Access Compliance Report

Public Rights-of-Way

(Curb Ramps)

Intersection ID: 7486	Main Street: TRYON_ST	Cross Street: OWEN_ST	Location: SE
ADA ID: 85F2E1A82F54	Ramp Type: Perp	Initial Pass/Fail: Fail	Overall Compliance: No
Severity Score: 12.5			
Codes/Mitigation Info/Possible Solution		Field Measurements/Component Compliance

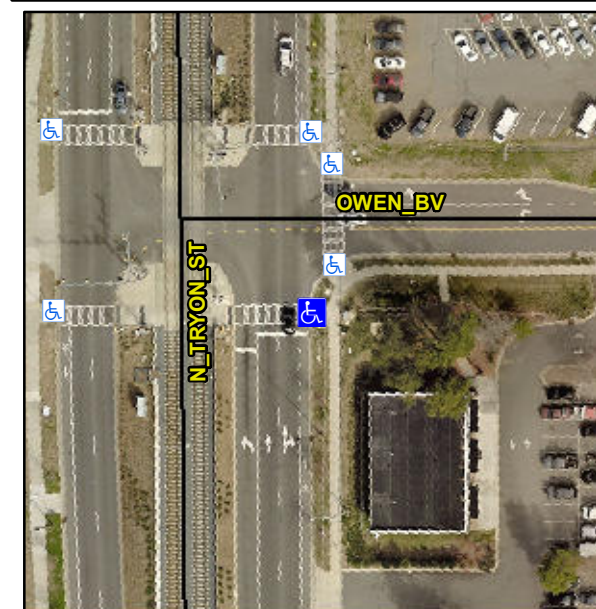
Not Found, R304.2.2

Compliance	Description	Data	Compliance	Description	Data
N/A	Ramp Length (in)	95.0	No	Ramp Slope (%)	9.1
Yes	Ramp Width (in)	94.0	Yes	Ramp XSlope (%)	0.5
N/A	Flare Type LT	N/A	N/A	Flare Type RT	N/A
N/A	Flare Slope LT (%)	N/A	N/A	Flare Slope RT (%)	N/A
N/A	Flare Traversable LT?	N/A	N/A	Flare Traversable RT?	N/A
N/A	Landing Length (in)	N/A	N/A	DWS Provided?	N/A
N/A	Landing Width (in)	N/A	N/A	DWS Contrast?	N/A
N/A	Landing Slope (%)	N/A	N/A	DWS Length (in)	N/A
N/A	Landing X Slope (%)	N/A	N/A	DWS Full Width?	N/A
N/A	Landing Curb? (Y/N)	N/A	N/A	DWS Offset (in)	N/A
N/A	Shared Landing?	N/A			
N/A	Gutter Ponding?	N/A	N/A	Gutter Slope (%)	N/A
N/A	Gutter Lip Ht (in)	N/A	N/A	Gutter X Slope (%)	N/A
N/A	Painted X Walk1?	Yes	N/A	Painted X Walk2?	N/A
	X Walk 1 Direction	To W		X Walk 2 Direction	N/A
N/A	X Walk 1 Width (in)	105.0	N/A	X Walk 2 Width (in)	N/A
	X Walk 1 Slope (%)	2.8		X Walk 2 Slope (%)	N/A
	X Walk 1 X Slope (%)	0.3		X Walk 2 X Slope (%)	N/A

Remove & Replace Entire Ramp.
